# Memo

**To:** Patricia Davis, P.E., Brad Marshall  
**From:** Jonathan Tran, P.E., Ron Mick, P.E.  
**Copy:** Matt Gaughan, P.E., Charles Cameron  
**Date:** November 12, 2021  
**Subject:** CWWTP1 Change Order 0005

For the Central Wastewater Treatment Plant Expansion project, the Owner's Representative Team recommends approval of the attached Change Order 0005 in the amount of \$125,009.25 and 113 additional days to the contract with BAR Constructors, Inc. as indicated in Table 1 below.

SHEET  
**S-UV-1**  
 SEQ. 181

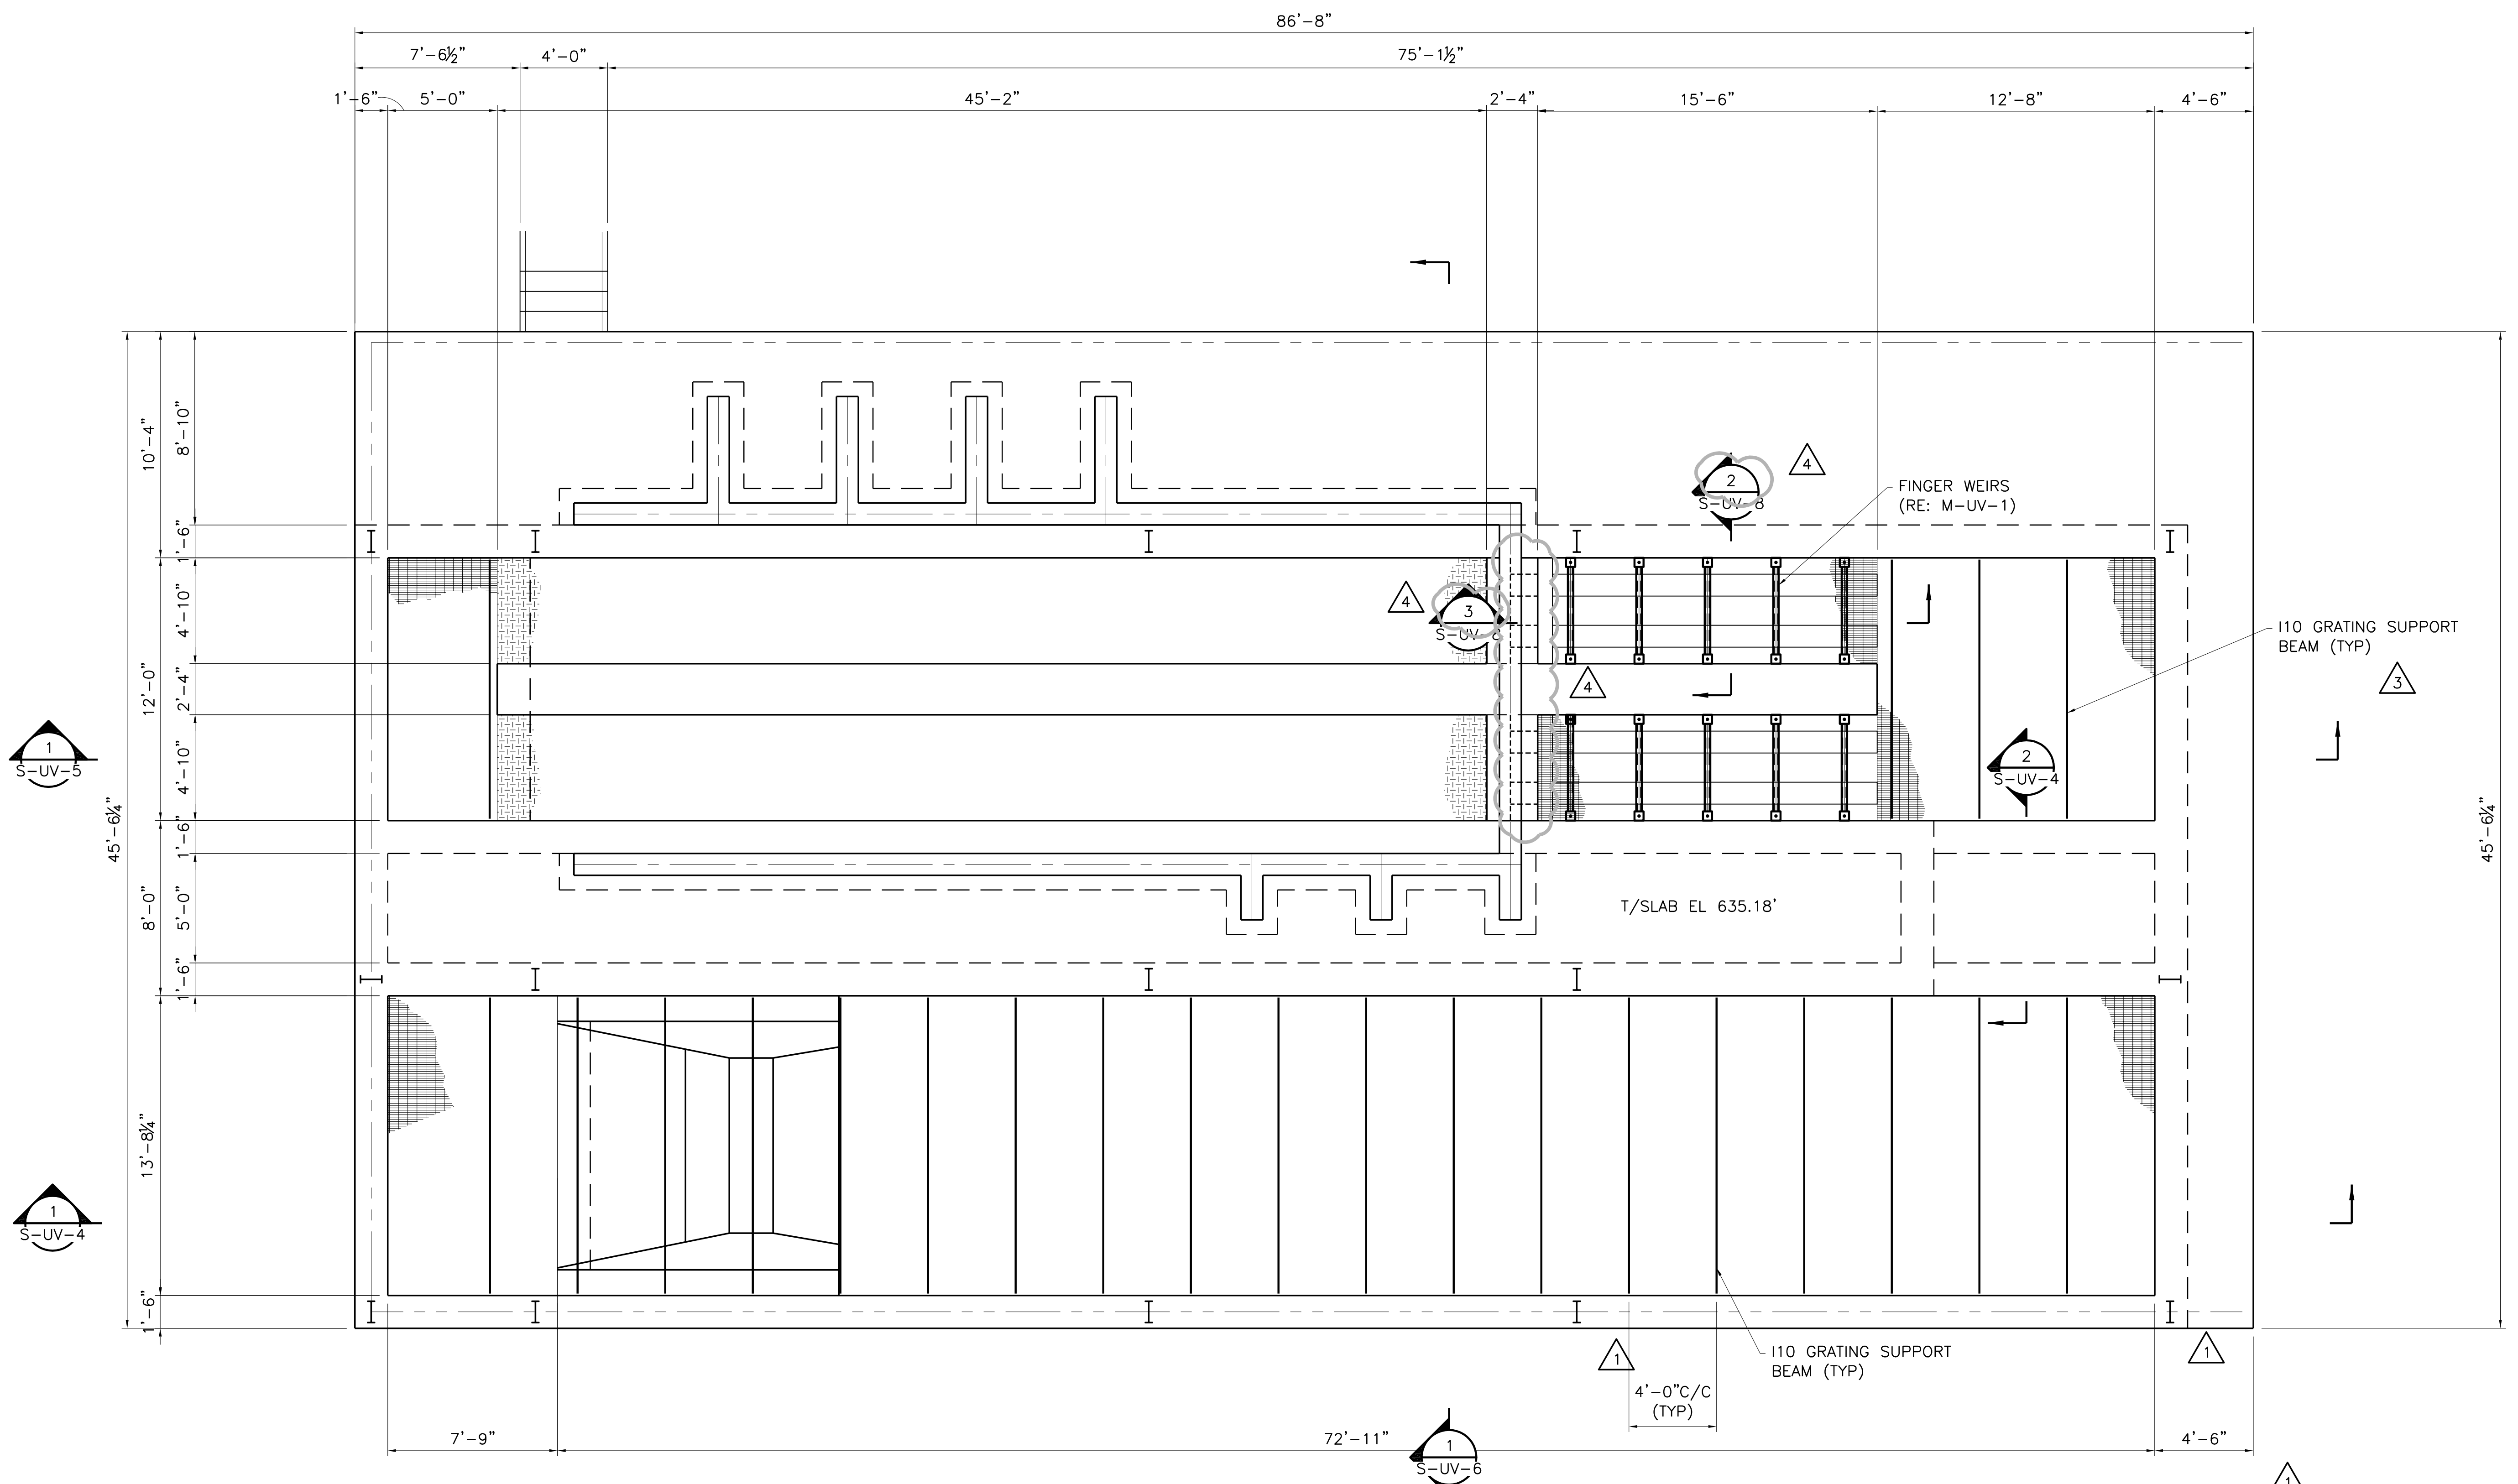
Concrete work at the UV basin was completed based on design drawings and approved shop drawings. After concrete was placed, it was discovered that the finger weir troughs were not open to receive flow through the finger weirs. Concrete was sawcut, removed and repaired in order to accept the correct finger weir system.

**RFI No.:** 110      **Description:** Finger Weirs at UV

**Response:** Per Engineer:  
See attached response.

SHEET S-UV-2

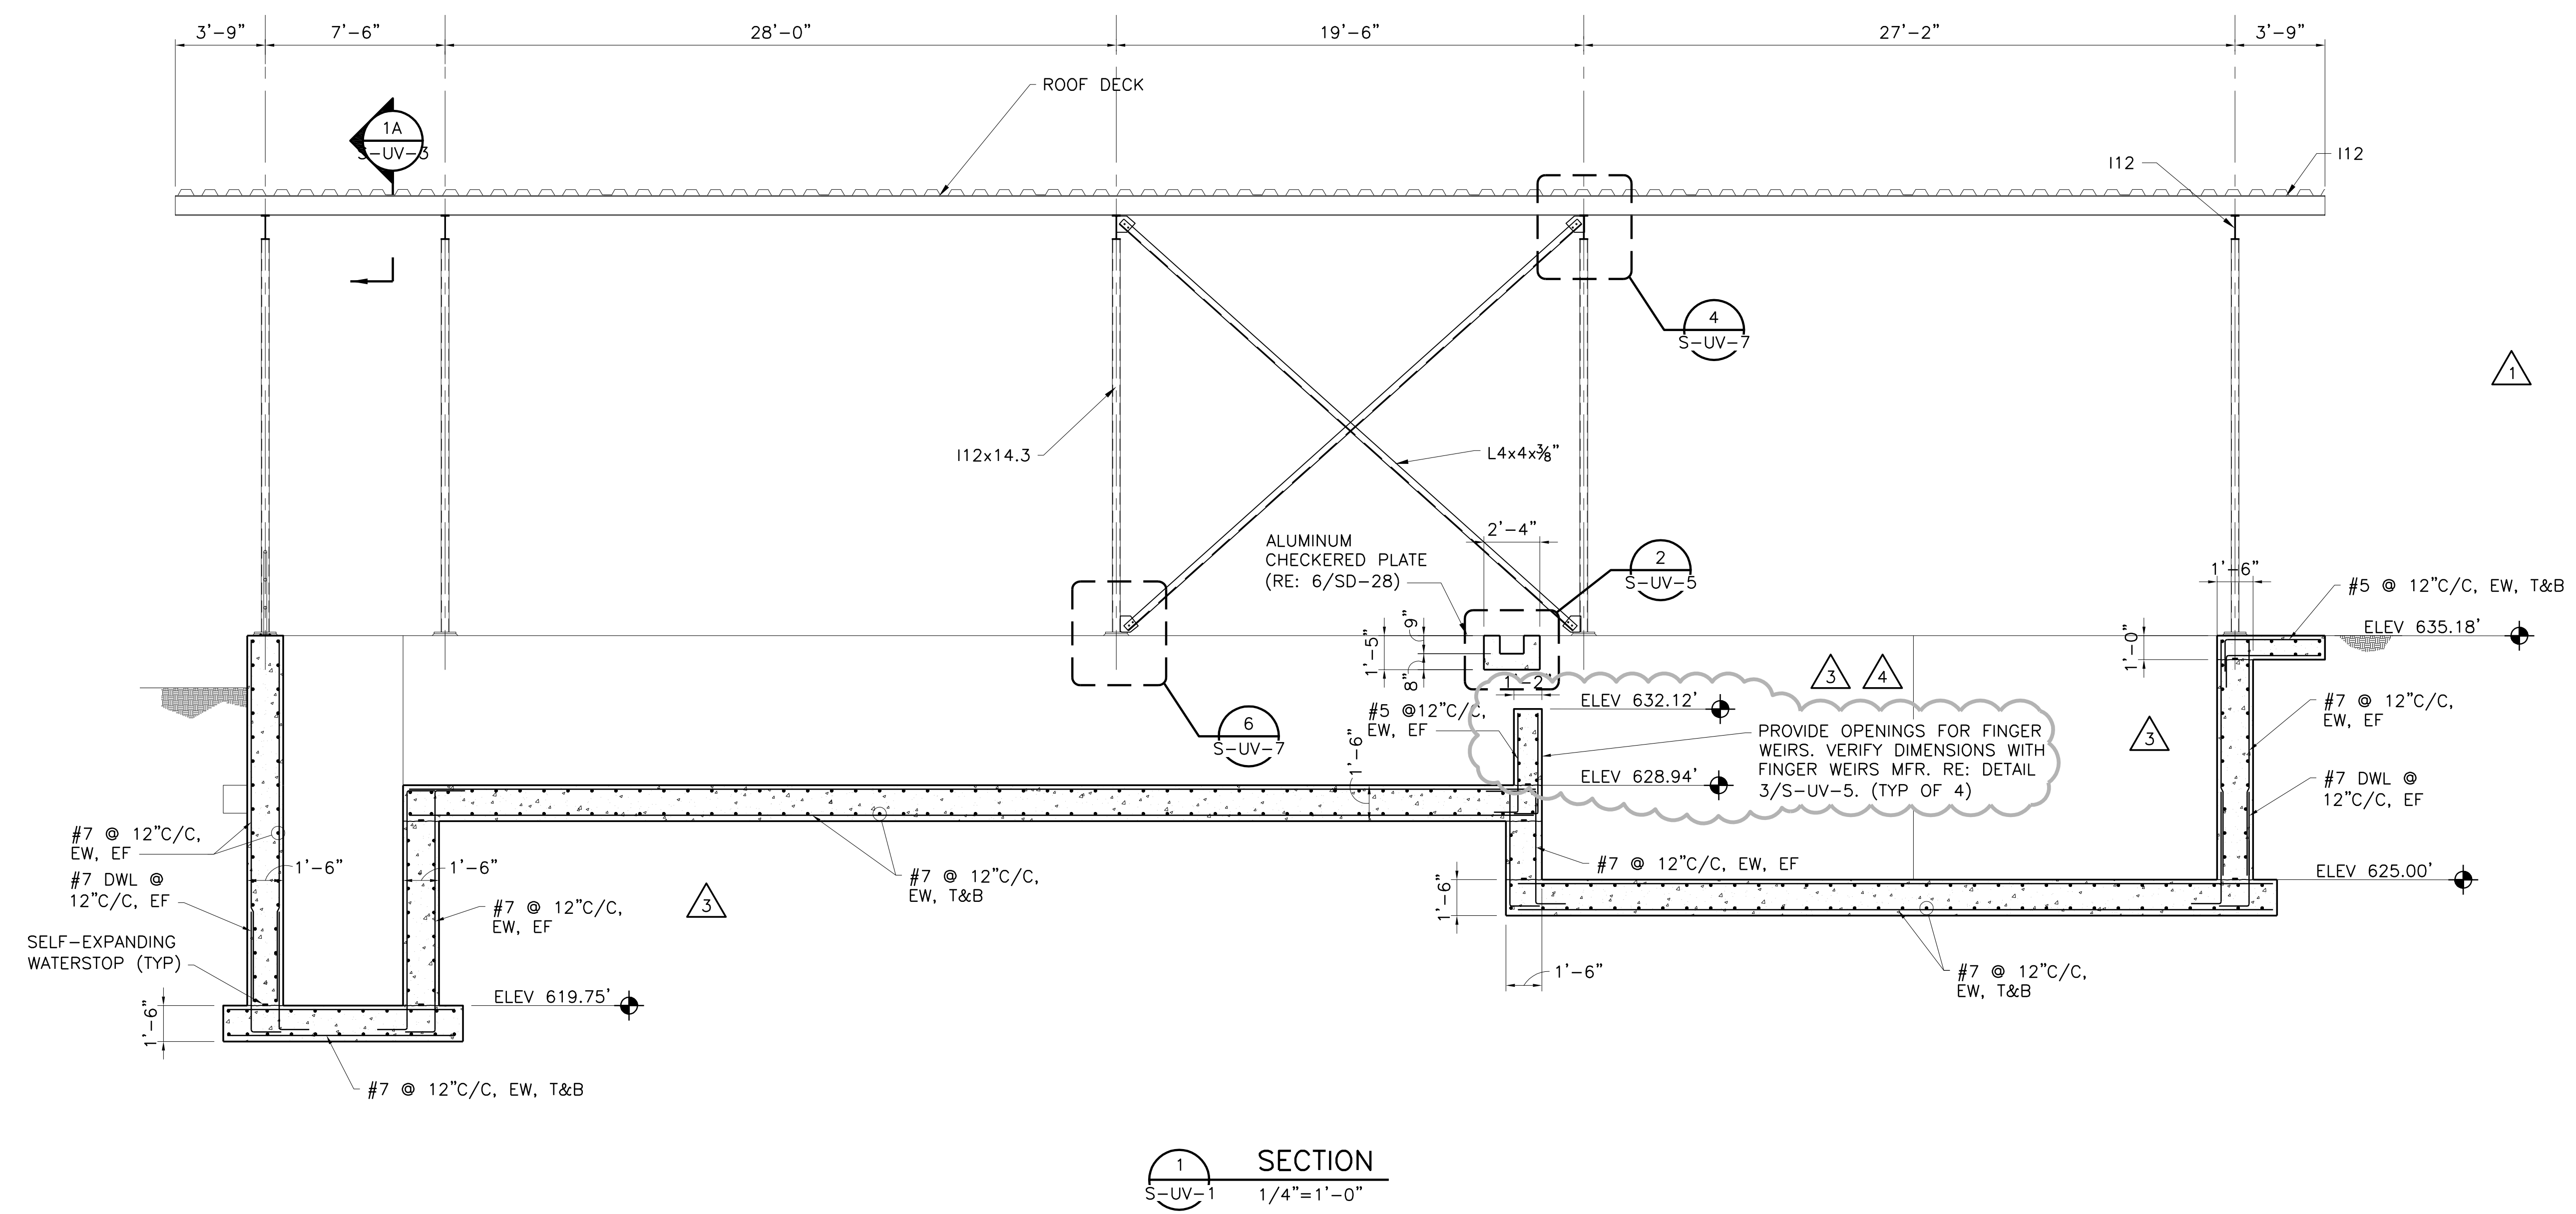
**Drawing No.:** S-UV-2      **Detail Description:** Finger Weirs at UV

NO.	ISSUE	BY	DATE	REV. NO.	DATE	DESCRIPTION	FILE NAME
1	RFP NO. 110	MRR	04/12/21	1	07/17/19	DESIGNED	PFL16607
2	RCP NO. 1 - ITEM NO. 3	MRR	02/10/20	1	07/17/19	DESIGNED	MRR
3	ISSUED FOR CONSTRUCTION	MRR	11/04/19	1	07/17/19	DRAWN	JLM
4	ADDENDUM NO. 2	MRR	09/04/19	1	07/17/19	REVISED	AD
